**Figure 2.1i**  
**Infrastructure Design Review**  
- Turbine 09

**Bhlaraidh Wind Farm Extension**  
**S36C Varied Development**

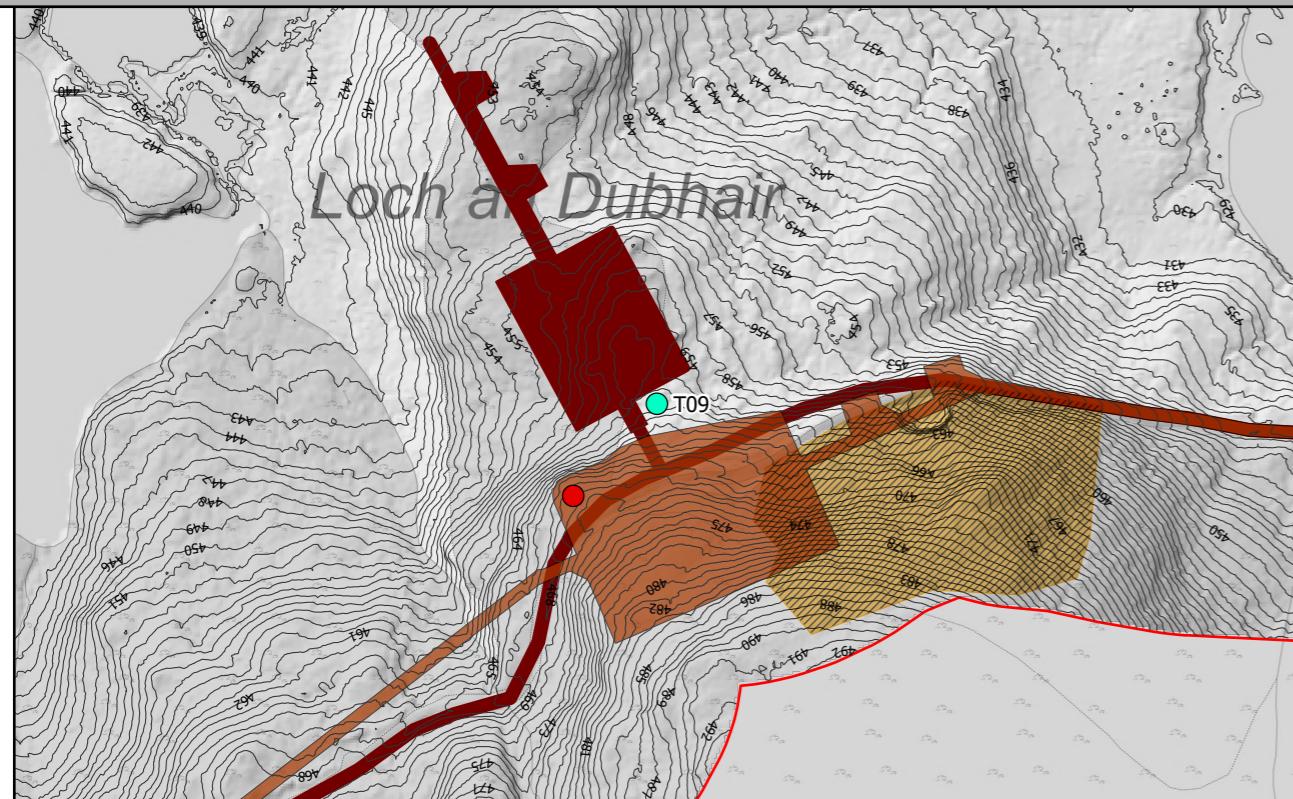
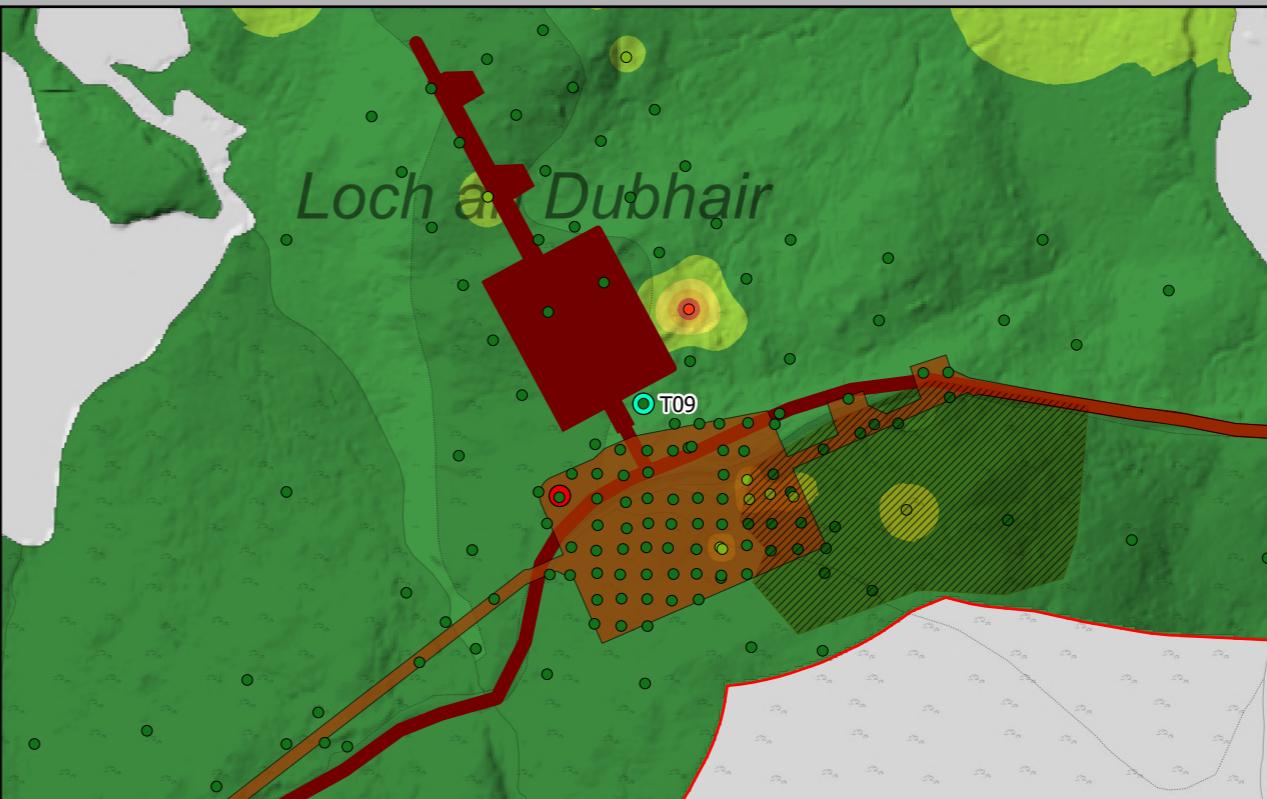
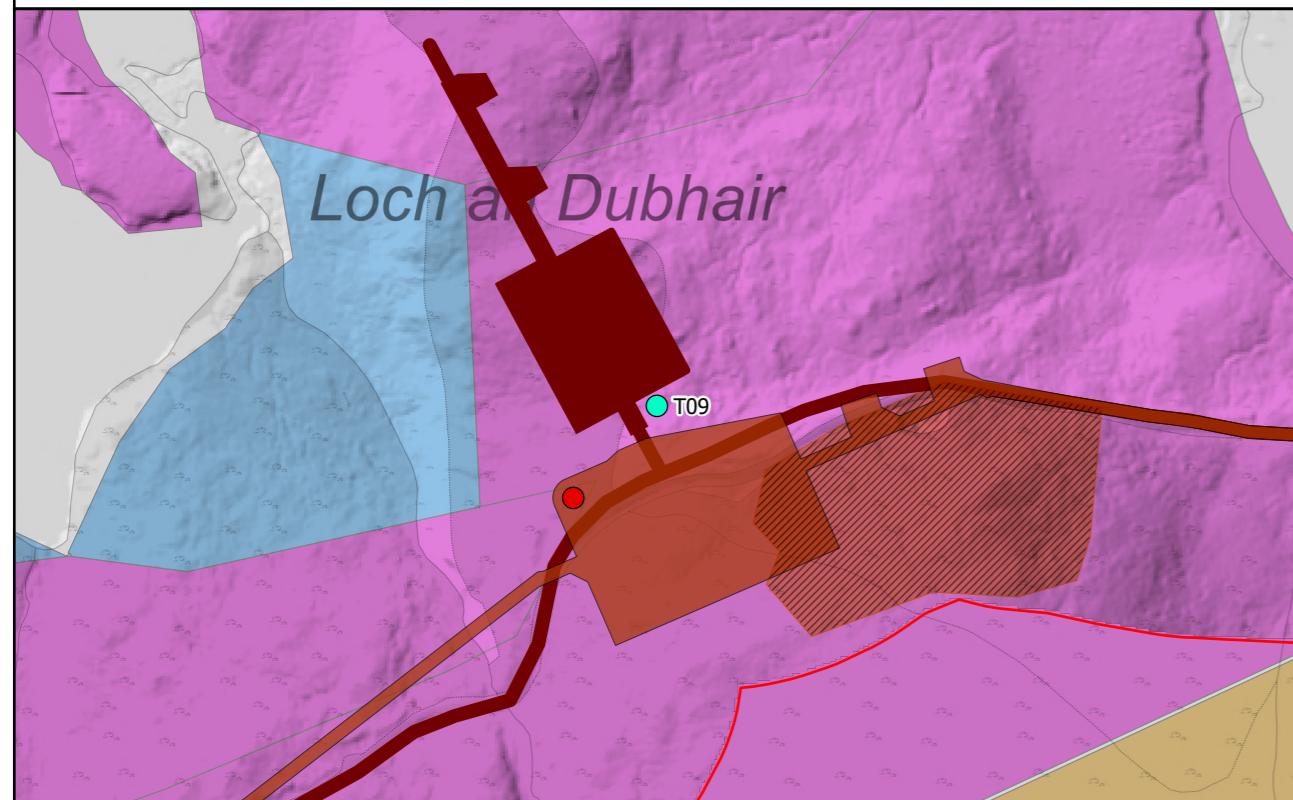
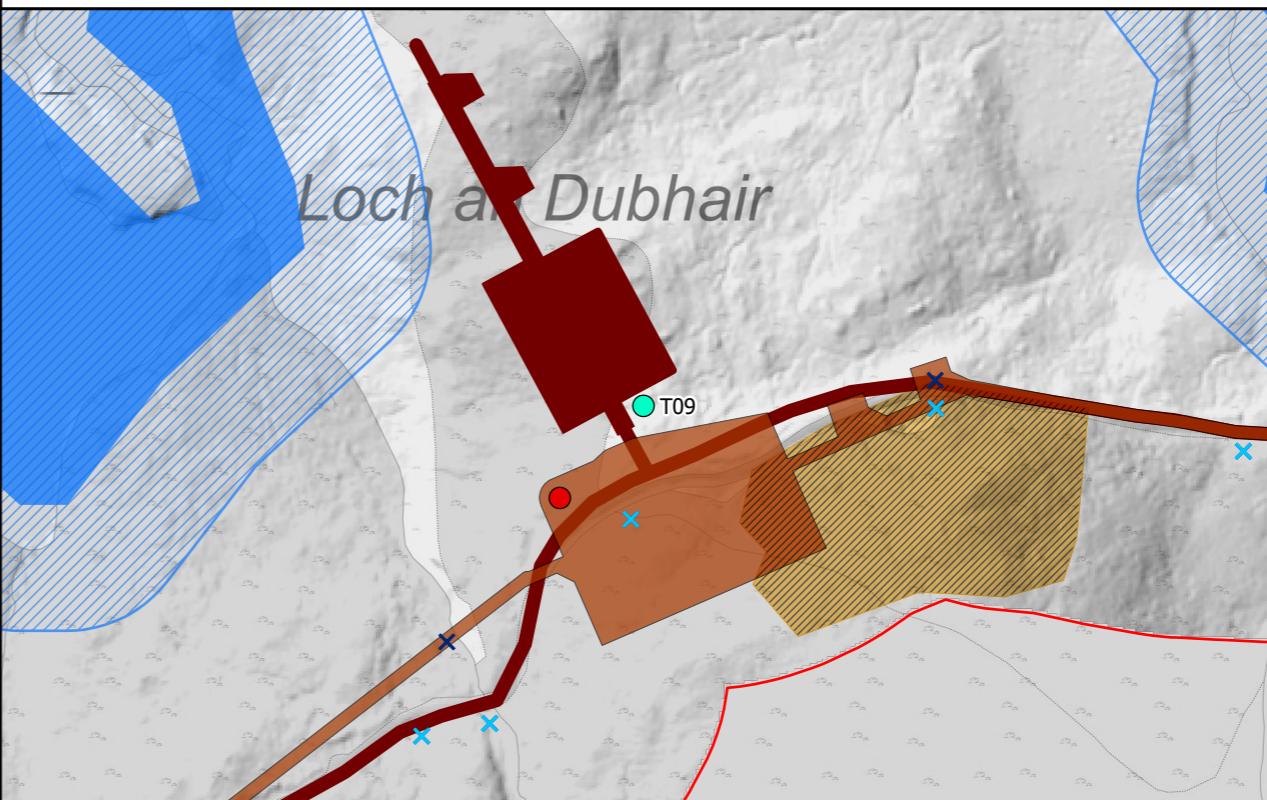
**T09: Reason for Moving:** This move was introduced to move the rotor swept area outside the 2nd Fresnel zone of the communications link between the existing Bhlaraidh Wind Farm site and Corrie Garth substation. This potentially eliminates the need to construct a new communication mast east of T16.

**Engineering:** The rotation of the hardstand allows for continuous drive without complex turning manoeuvre onto a separate spur, simplifying the component delivery strategy.

**Geology Impacts:** The current consented orientation of the hardstand required significant volumes of fill material to construct. By rotating the hardstand to align with the track, these cut/fill volumes can be balanced. All infrastructure is constructed within areas of shallow peat. All proposed infrastructure is within the 50m micrositing buffers allowable within the current consent.

**Ecology Impacts:** The proposed turbine location has significantly less impact on the "200m Bat B10 Buffer" that centres to the north east of the turbine location. Moving the turbine and hardstand locates the infrastructure predominantly in Wet Heath (M15c), further away from the Blanket Mire (M17/M17a/M18a/M19a) than the consented layout occupied.

**Hydrology Impacts:** Introducing the larger hardstand required for the turbines being considered for the project, would have encroached on the 50m water course buffer to the north east of the consented location. By rotating the hardstand, the infrastructure is now out side any water course buffer. There are existing water course crossings along the existing site track, these will need to be managed as part of the works to complete the project. This is the case for both the proposed and consented layouts.
